Regulatory, Planning and Assessment.MBisson/GMansfield
Reference: SDC2021/0007.01
Phone: 02 4974 2000

NEWCASTLE CITY BYPASS (SSI-6888-MOD-1) – ADDITIONAL ANCILLARY FACILITIES

The submitted Modification Report has been reviewed and the following advice is offered for your consideration:

FIGURE 4a

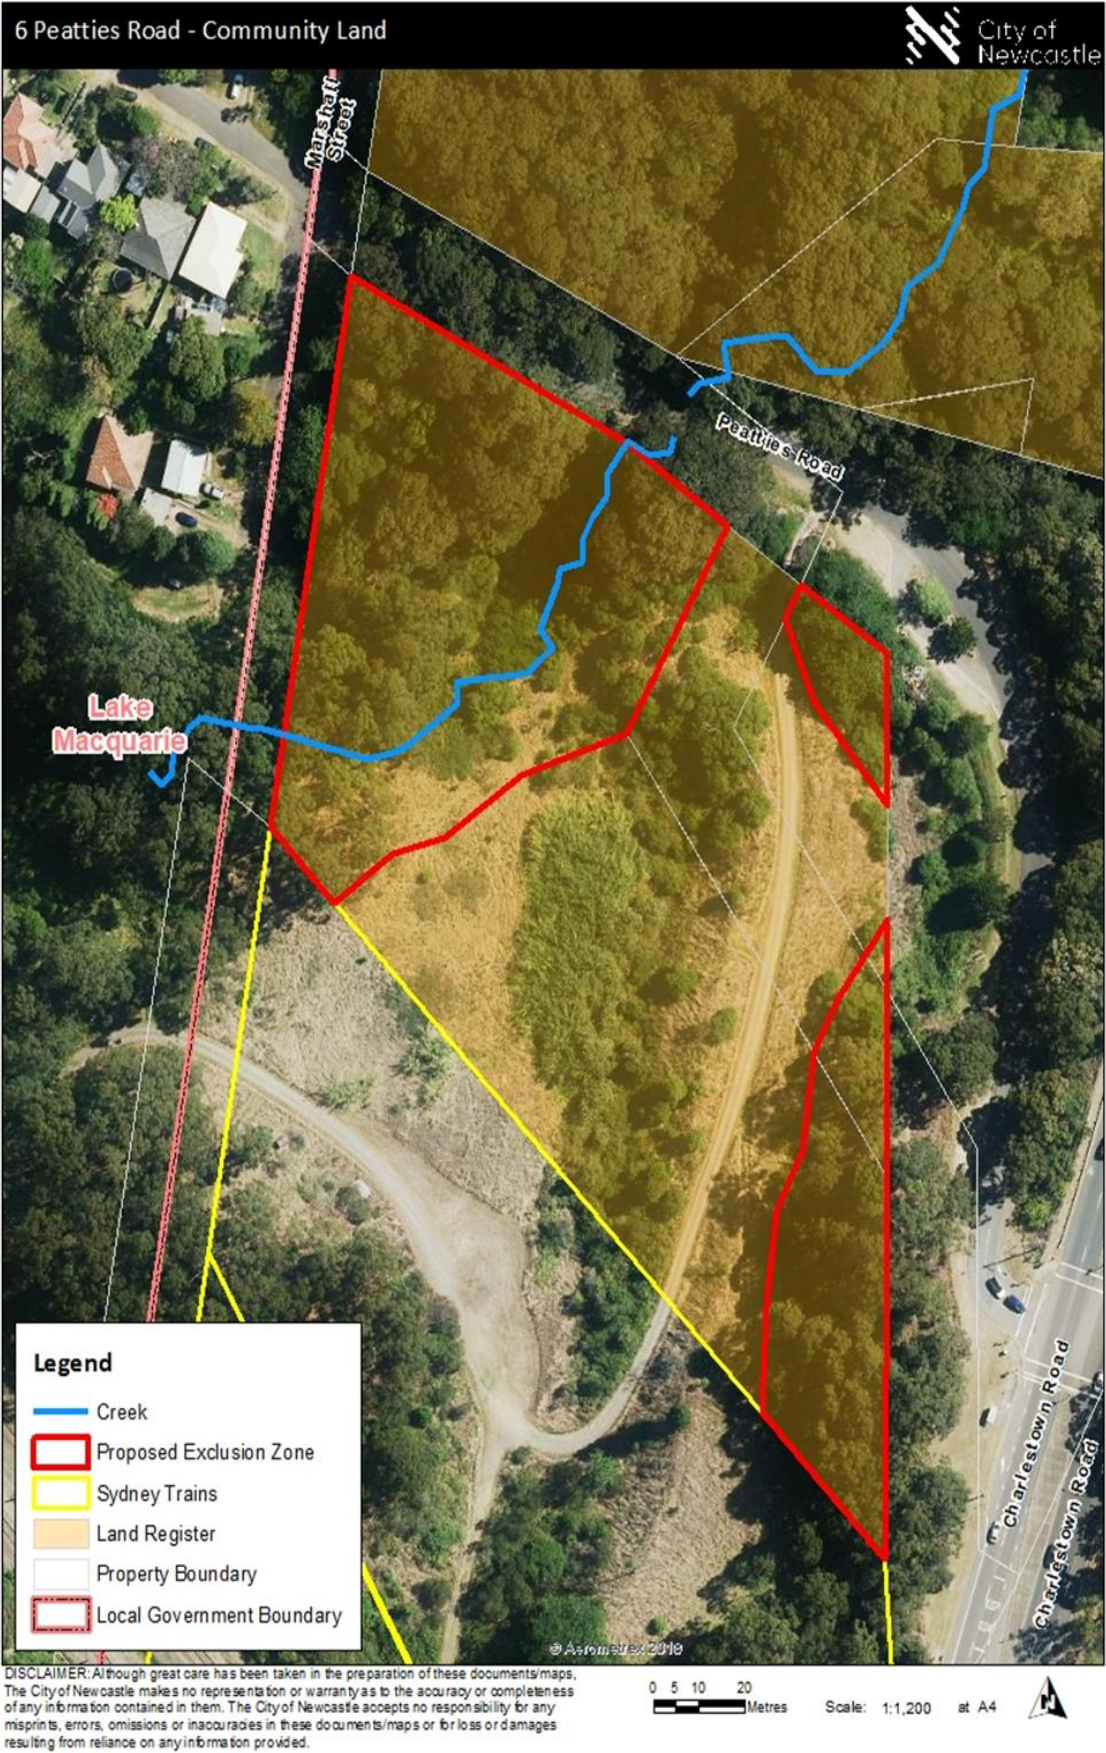
- All light spill from the compound site into the site's bushland and creek corridor (refer Fig 4a below) is to be mitigated.
